# UNITED STATES PATENT AND TRADEMARK OFFICE

APPLICATION NO.	FILING DATE	FIRST NAMED INVENTOR	ATTORNEY DOCKET NO.	CONFIRMATION NO.
09/666,553	09/21/2000	Yasuhiko Nomura	001222	7592

# Office Action Summary

## DETAILED ACTION

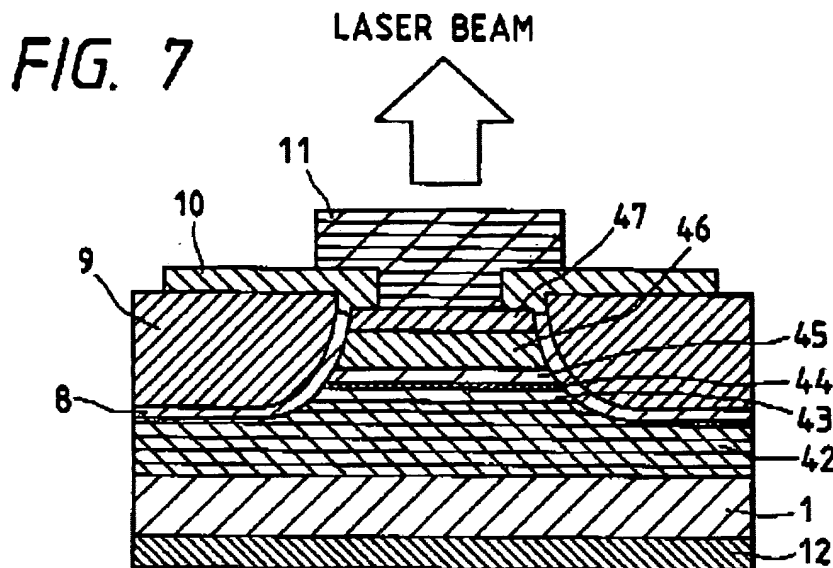
In response to applicant's first argument, it is disagreed that Kondow does not teach the additional limitation, as stated above. First, attention is directed to applicant's figure 3, which shows a dielectric film 12B formed on a surface of a nitride-based semiconductor layer including an emission layer (7). Note that the dielectric film (12B)

contains a nitride (112a or 112b) on the side of the interface between the dielectric film (12B) and the nitride-based semiconductor layer (including layer 7). Also the dielectric film (12B) contains an oxide (either 112b or 112c) on the side opposite to the nitride-based semiconductor layer (including layer 7). Similarly, since Kondow discloses a dielectric Bragg reflector (11) comprising alternately stacked SiN and SiO layers, there is at least one SiN layer that is positioned closer than at least one SiO layer to the nitride-based semiconductor layer.

In response to applicant's second argument above, it is disagreed that "directly" must be read into the claim and further it is disagreed that applicant is claiming that the nitride film is formed directly on the surface of the nitride-based semiconductor layer, because applicant has claimed a broader scope which does not require it. The claim requires that a dielectric film be formed on a surface of the nitride-based semiconductor layer. Kondow teaches this. The claim requires that the dielectric film contain a nitride *on the side* of the interface between the dielectric film and the nitride-based semiconductor layer. It does not require that the dielectric film containing a nitride directly at the interface, as argued by applicant.
